**SUBJECT:** Amendment Application for NUHOMS<sup>®</sup>-MP187 Transportation Package (Docket No. 71-9255)

Transnuclear West Inc. (TN West) herewith submits a revised drawing for the NUHOMS<sup>®</sup>-MP187 package. TN West requests that Certificate 71-9255 be revised to incorporate this drawing change. A detailed description and technical justification for the change are provided in Attachment 1. The revised drawing, provided as Attachment 2, is:

NUH-05-4001, "NUHOMS<sup>®</sup>-MP187 Multi-Purpose Cask Main Assembly," Revision 11.

**Description and Justification for Change**

Figure 1, Inner Shell Closure Weld Geometry

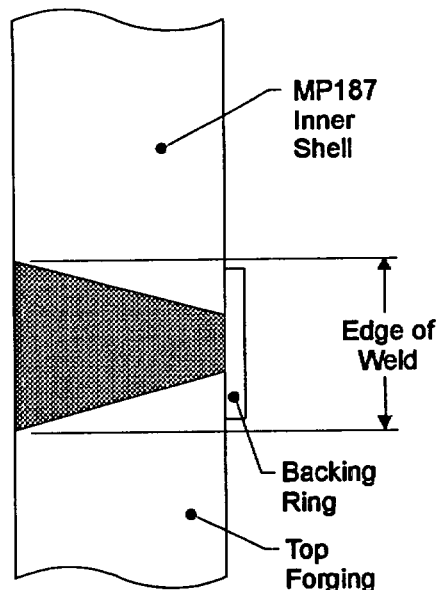
*Description:* The weld between the MP187 cask inner shell and top forging includes a 1/8 inch thick by 1.0 inch wide backing ring as shown at coordinate C5 on sheet 3 of drawing NUH-05-4001, Revision 10. This backing ring facilitates completion of this containment weld and remains a part of the completed cask. As shown on the revised drawing provided with this application (NUH-05-4001 Revision 11), TN West proposes to increase the size of this ring to 1/4 inch thick by 2.0 inches wide.

*Reason for Change:* The original size of the backing ring was selected to both minimize its impingement on the lead shielding present in the cask and to completely cover the root of the weld. The backing ring design was also consistent with the originally proposed inspection requirements for the weld - multi-layer dye-penetrant examination. However, in the final stages of cask licensing the examination requirements for this weld were revised to require volumetric examination by either radiographic or ultrasonic means. As shown in Figure 1, the edge of the existing backing ring will be visible in the volumetric examination and may appear as an indication or may mask the presence of indications. Revising the width of the ring to remove the edge from the area to be inspected will improve the quality of the volumetric examination.

Increasing the thickness of the backing ring from 1/8 inches to 1/4 inches will facilitate completion of this containment weld by reducing the potential for melt-through and distortion.

*Justification:* Changing the size of the backing ring has no impact on the structural, thermal, criticality, or containment analyses or on the use of the package. No credit is taken for the ring in the structural or containment analyses. The small size of the ring and its location outside of the active fuel region ensures that the proposed changes will not affect the thermal or criticality analyses. Because the ring displaces a portion of the cask's lead gamma shield, the impact of this change on the shielding analyses presented in Chapter 5 of the SAR is addressed below.

As shown on the drawings provided with this submittal, the inner shell weld and backing ring are 16.0 inches below the top of the cask. Based on the shielding models described in the MP187 SAR, the dose rates at this location assuming that no backing ring is present are 21.5 mrem/hr (surface of package and vehicle outer surface) and 4.91 mrem/hr (2 meters from vehicle outer surface). These results are shown in Table 2 (column labeled "Dose Rate w/o Ring").

The effect of the backing ring on the calculated dose rates is bounded using the "base case" 1-dimensional model described in Section 5.4.1.8.1 of the SAR and provided in Section 5.5.5.1 of the SAR. The neutron and gamma dose rates on the surface of the cask calculated by this model are shown in Table 1 (column labeled "1-D Base"). By modifying the 1-D model to replace either 1/8 inch or 1/4 inch of lead with steel over the entire length of the cask (infinite axial model), TN West bounds the effect of the steel backing ring. Using this model, TN West estimated the change in the package dose rates related to the presence of the existing ring as well as the proposed change. The 1-D results on the surface of the cask are provided in the Table 1 ("1-D for 1/8 in Ring" and "1-D for 1/4 in Ring"). Ratios relative to the base case are calculated for both the 1/8 in ring and the 1/4 in ring as shown in Table 1.

The dose rates on the package and vehicle surfaces (these are identical in the vicinity of the backing ring) and 2 meters from the vehicle surface in the region adjacent to the backing ring are estimated by multiplying the dose rate without the ring by the ratios shown in Table 1. As shown in Table 1, the presence of the ring actually reduces the neutron dose rate on the surface while increasing the gamma dose rate locally. To bound the results the neutron dose rates are not adjusted (refer to column "Ratios Used Below" in Table 1). This is consistent with the fact that the steel ring is a better neutron shield than the lead it displaces and the lead is a better gamma shield than the steel.

The calculated dose rates on the package surface, vehicle outer surface, and 2-meters from the vehicle outer surface are shown in Table 2. The dose rates without the backing ring are taken directly from the MP187 shielding results presented in Chapter 5 of the SAR. The dose rates with the ring are bounded using the ratios from Table 1. The surface dose rates and the 2-meter dose rate increase slightly (less than 4% and 2% respectively), but remain well below the limits at these locations (200 and 10 mrem/hr respectively). The controlling dose rate 2-meters from the vehicle outer surface, 9.94 mrem/hr, is unaffected by this change. Copies of the computer run input are included in Attachment 2.

Based on these results, TN West concludes that the proposed change to the MP187 package will not affect the package's ability to satisfy the requirements of 10CFR71.47 for normal operations. Because the dose rates associated with the hypothetical accident conditions are dominated by postulated gaps in the lead shielding, the presence of the backing ring will not affect compliance with the limits specified in 10CFR71.51.
